PROBLEM *Solver* BULLETIN

Premature Wear of Upper Ball Joint

Dodge Ram 2500/3500 4WD,
Ram 1500 w/Mega Cab

MOOG® K7460 Upper Ball Joint

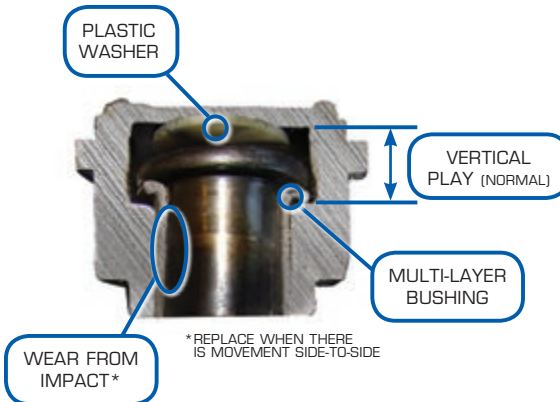
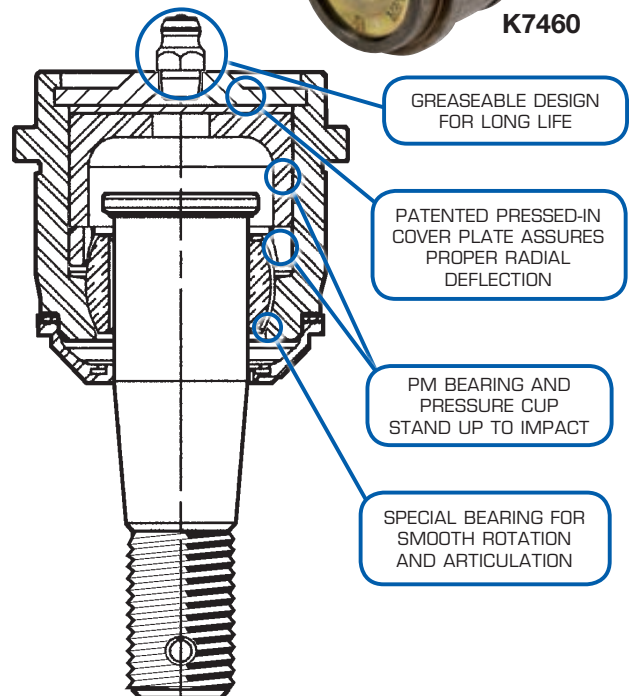
Premature ball joint failures on many late-model Ram trucks are a common occurrence on vehicles equipped with the 9.25" axial.

The installation process puts significant demands on the upper ball joint bowl design. The upper and lower ball joints on these axles may not be perfectly aligned. The OE ball joint design deforms to comply to these demands. This leads to severe wear from impact loads occurring under "normal" driving conditions. The ball joints should be replaced any time there is side-to-side or back-and-forth "radial play" (vertical-only movement is normal).

OE DESIGN IS NON-SERVICEABLE

The K7460 design has a patent-pending all-metal bowl design that compensates for suspension component misalignment, and a patented closure method that minimizes radial deflection. In addition, the MOOG K7460 uses a premium polychloroprene boot with a built-in grease-relief valve, providing a sealed, serviceable part able to flush contamination.
